## ADDENDUM

Reference: Utah National Guard – Ogden Armory  
Roofing, Mechanical, Electrical, and Window Improvements  
DFCM Project No. 05040470

Subject: **Addendum No. 1**

## ELECTRICAL ADDENDUM ITEMS

**SITE PLAN KEYED NOTES:**

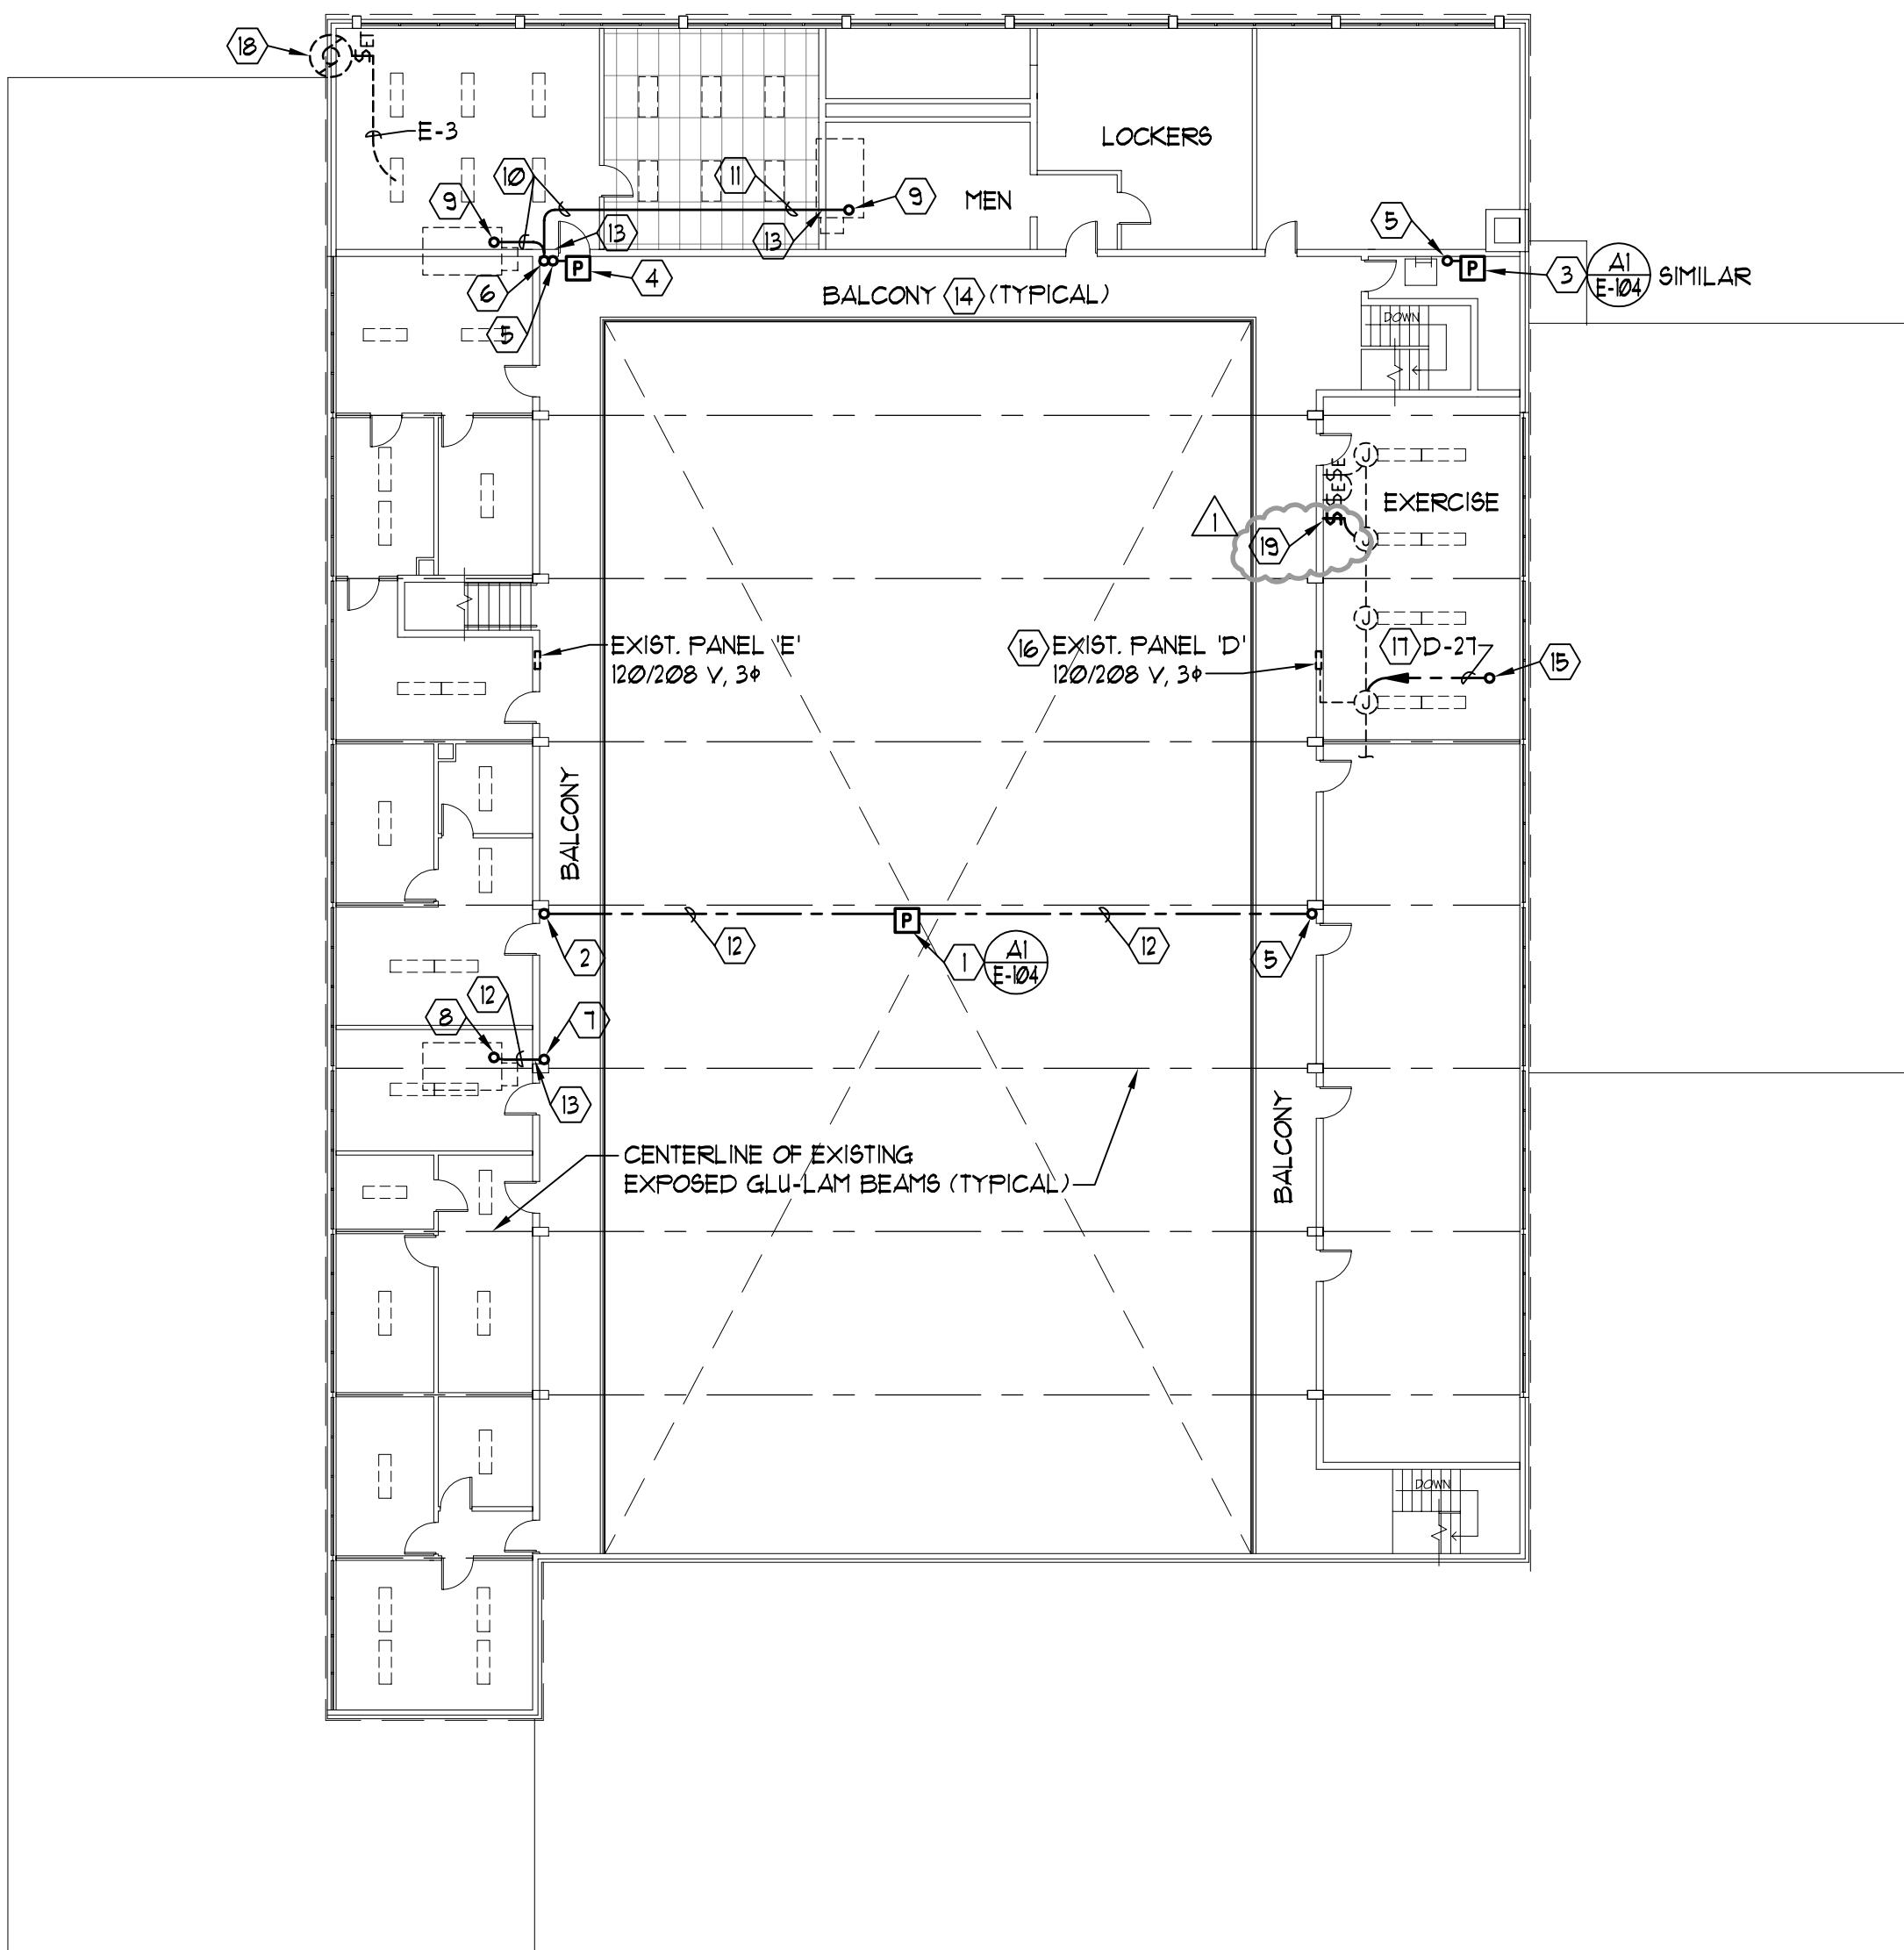
1. Change Overhead Electrical Service to Underground Electrical Service.
  - A. Change Overhead Electrical Service to Underground Electrical Service as shown on Electrical Drawings, Revision No. 1.

- B. Work for underground electrical service includes, but is not limited to, the following:
    - 1) New underground conduit from existing power pole to new pad mounted transformer.

- 2) New precast concrete vault with precast concrete lid.
    - 3) New separately mounted current transformer cabinet, meter base, and main breaker.

- 4) New underground secondary conduit and conductors as indicated on drawings.
    - 5) Sawcut, remove, and replace existing asphalt paving and concrete slabs necessary to install new underground electrical service.

## POWER RISER DIAGRAMS AND PANEL SCHEDULES

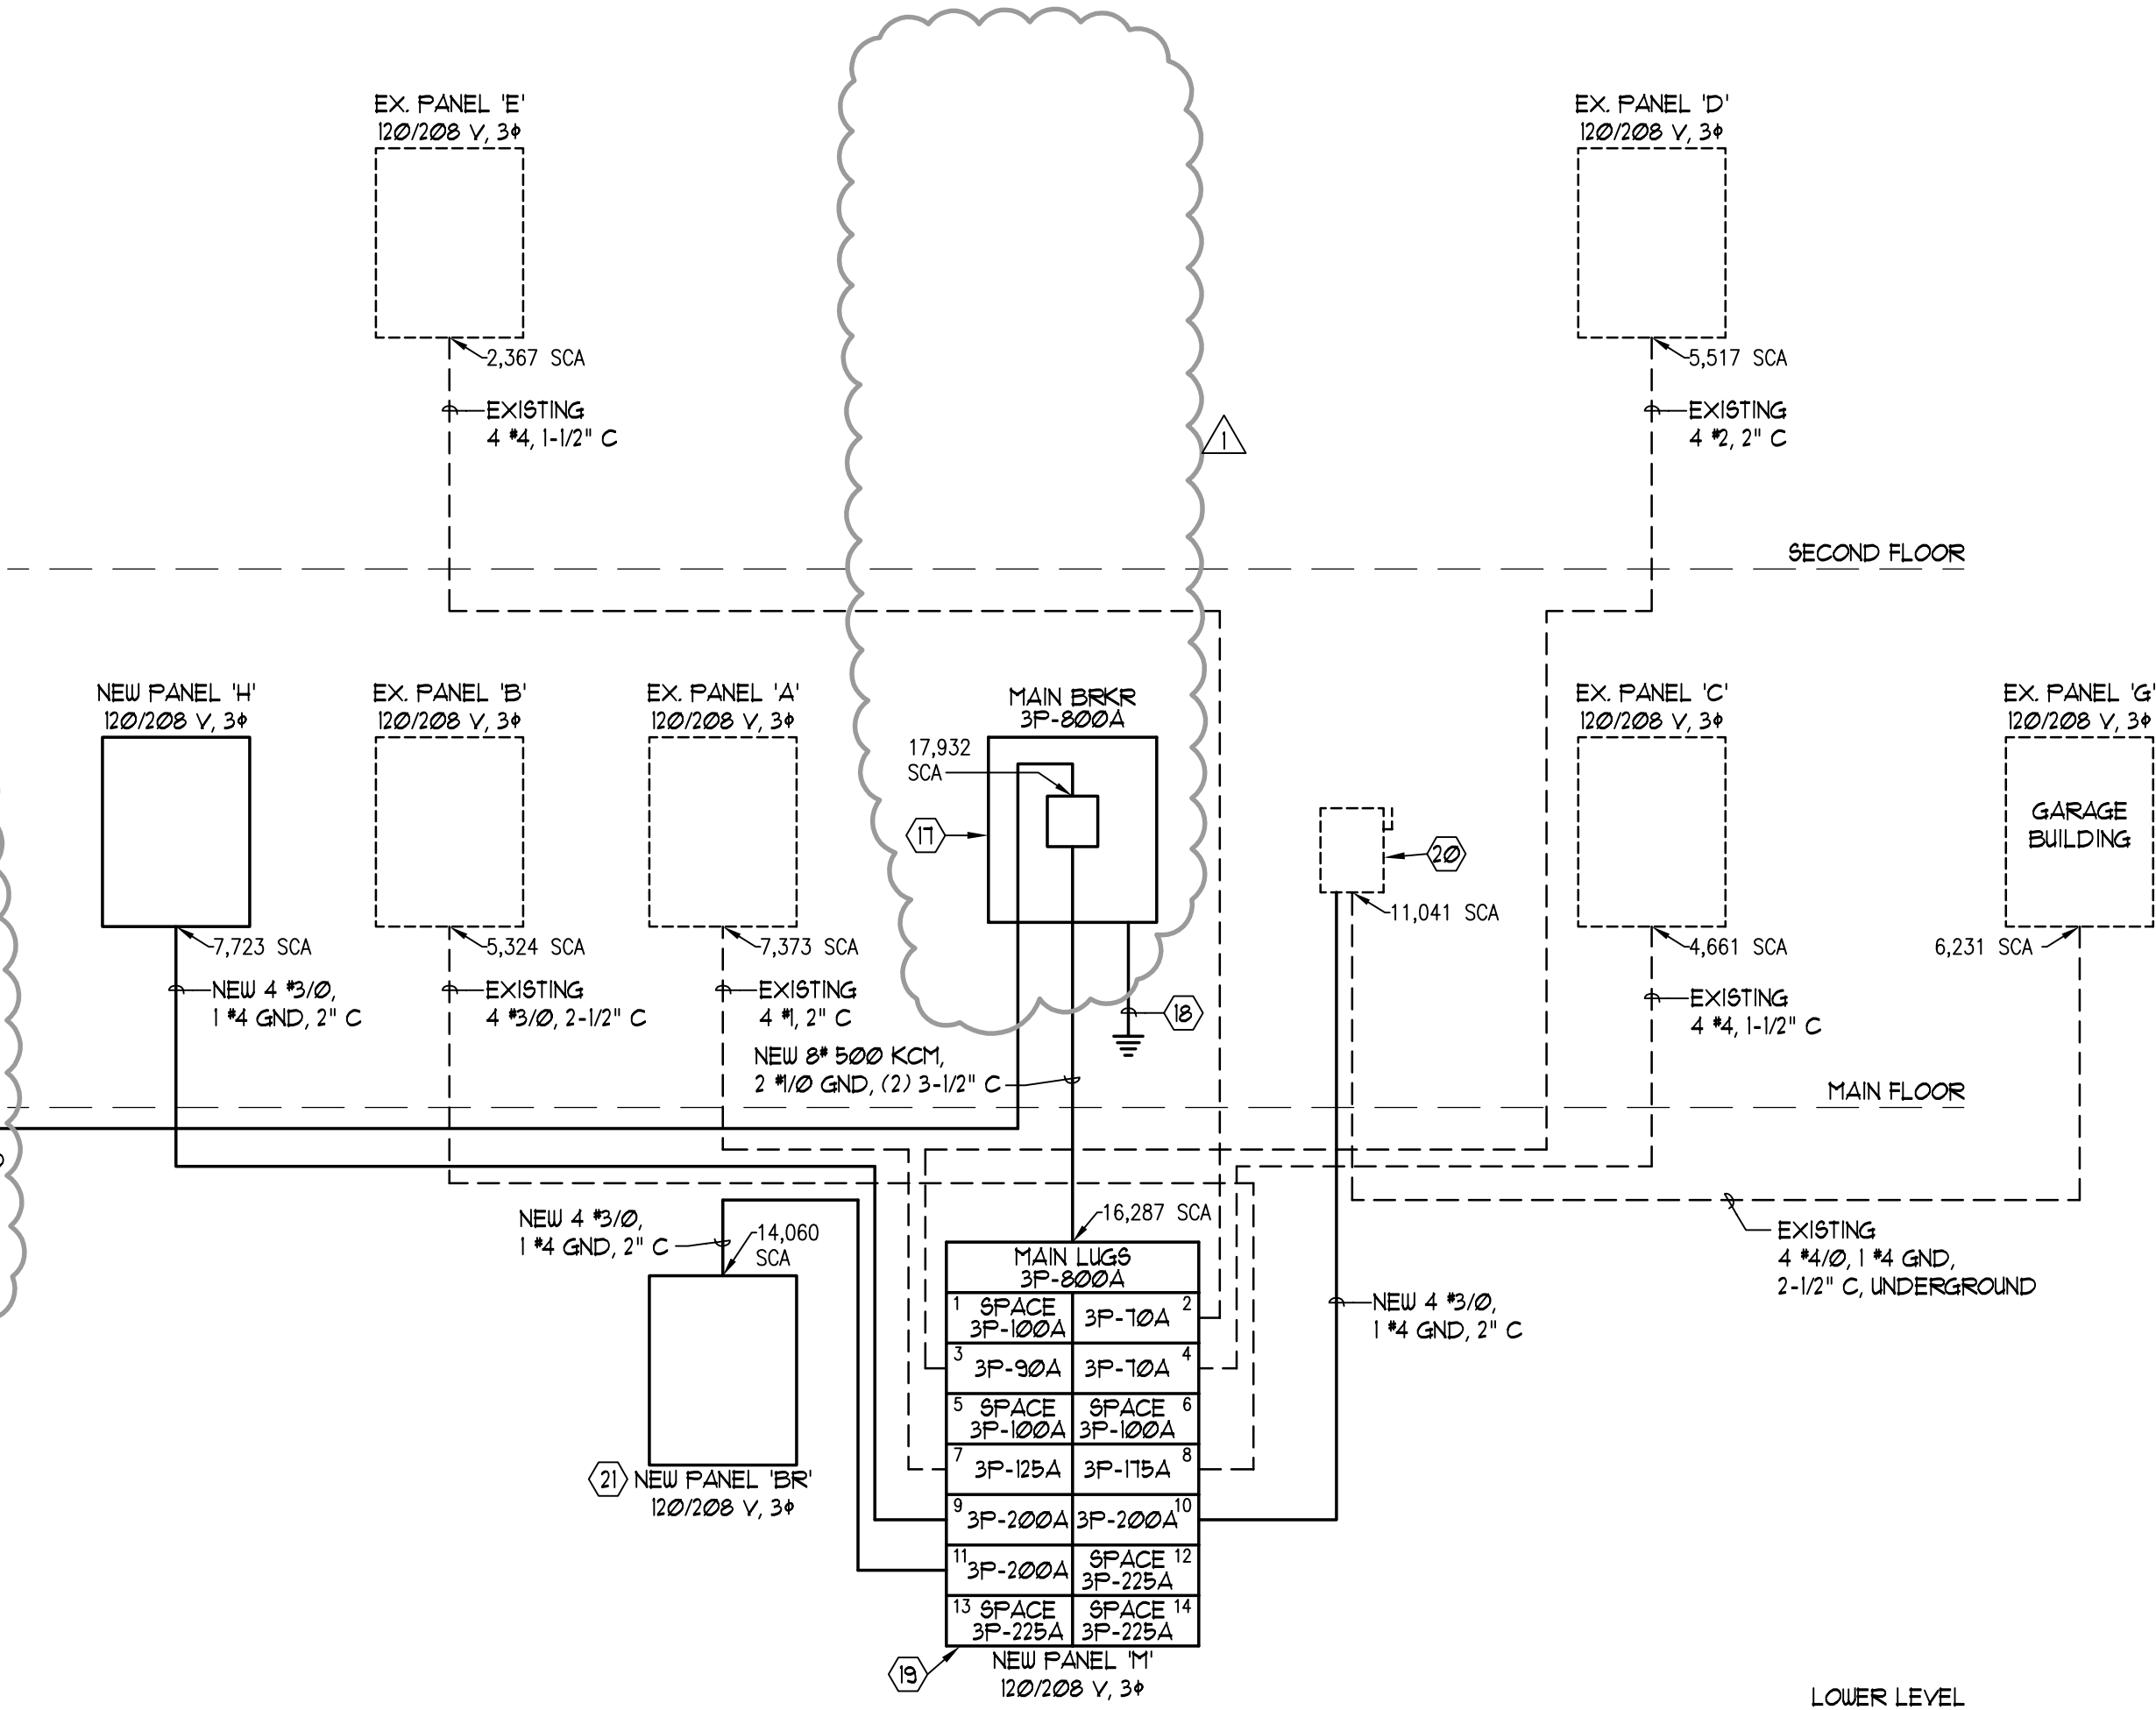
- D. Delete references to Metering Switchboard in Specification Section 16400, Paragraph 2.3, and Section 16470 Paragraph 2.2. Provide separate metering cabinet, meter base, and main breaker indicated on Electrical Drawings, Revision No. 1.
